Technical Memorandum

**Re: Southminster Church – 1040 Bank Street
Residential Development – Parking Review**

Figure 1: Existing On-Site and On-Street Parking

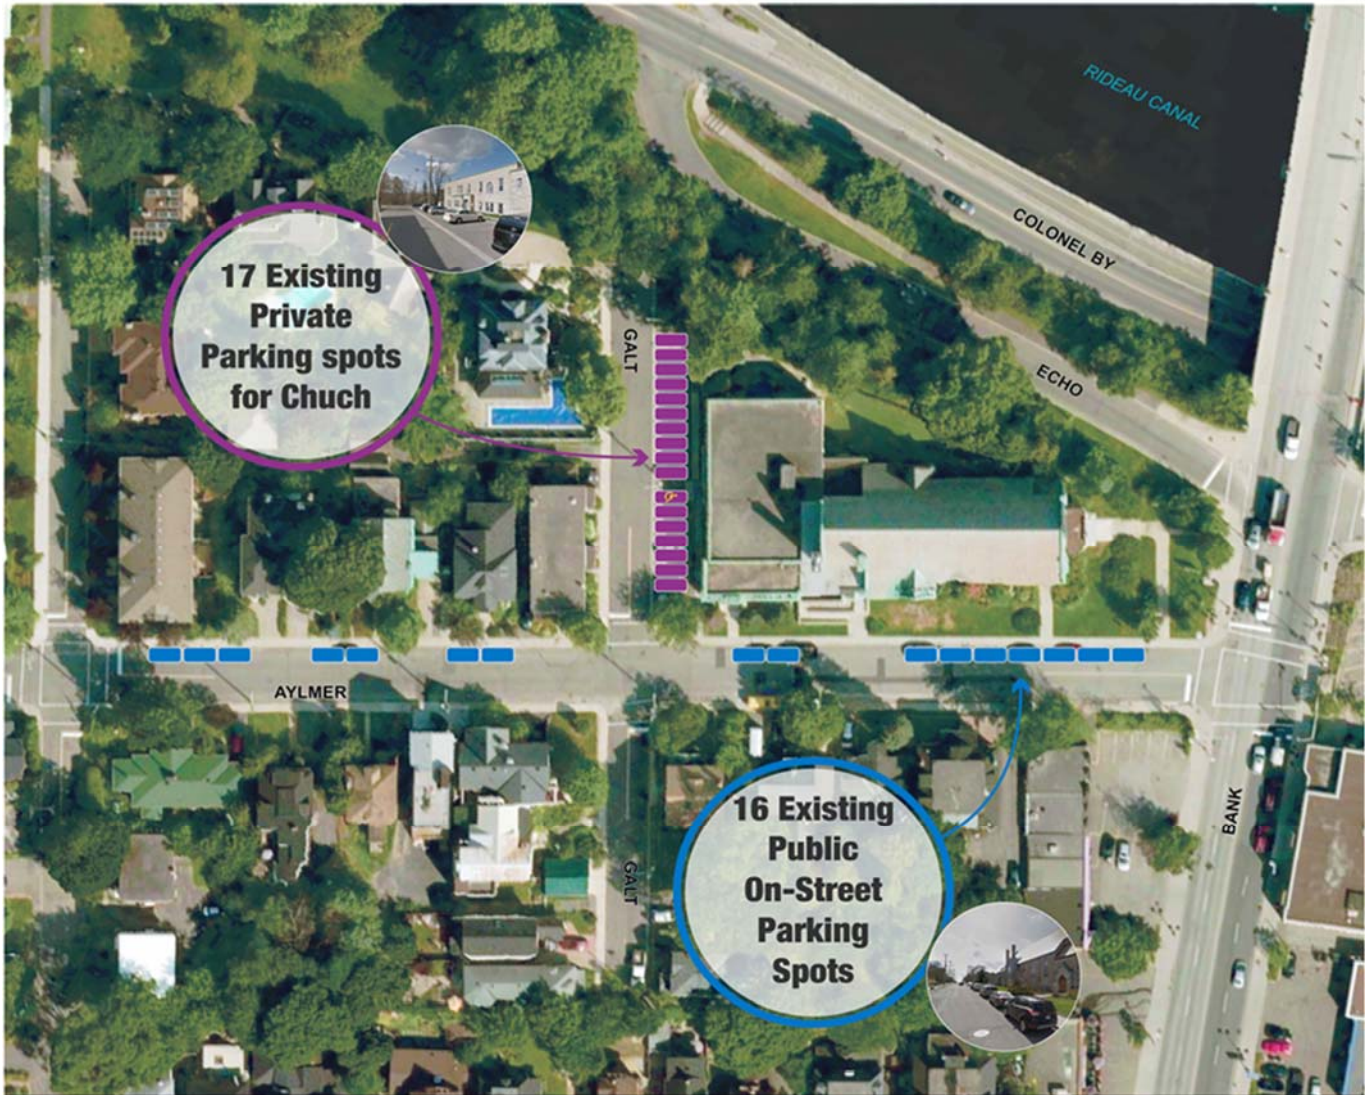
Comment 12: Please provide a parking study prepared by a qualified professional assessing supply and demand for on-street parking within the surrounding neighbourhood (approximately 400 metres).

Response 12: Based on a preliminary assessment of the area, within a 450 m walking distance from the site, there are approximately 121 existing on-street parking spaces. This is outlined in Table 1 below. The 17 private parking spaces on the subject site are not included in this count.

The planned increase in on-street parking is 7 spaces along Galt Street, for a total of 128 public on-street parking spaces within the vicinity of the church. Assuming church staff/members will use the proposed 7 on-street parking spaces along Galt Street, the increase demand for on-street parking in the neighborhood would be 10 additional vehicles or less (i.e. 7 planned public parking spaces to be added - 17 private parking spaces to be removed = -10 net difference of vehicle parking in the area).

A parking study showing occupancy of on-street parking spaces will likely not provide any additional information and the future operations of parking for church and other events at the subject site will be similar to the existing condition, as there is an increase parking demand of 10 vehicles (or less).
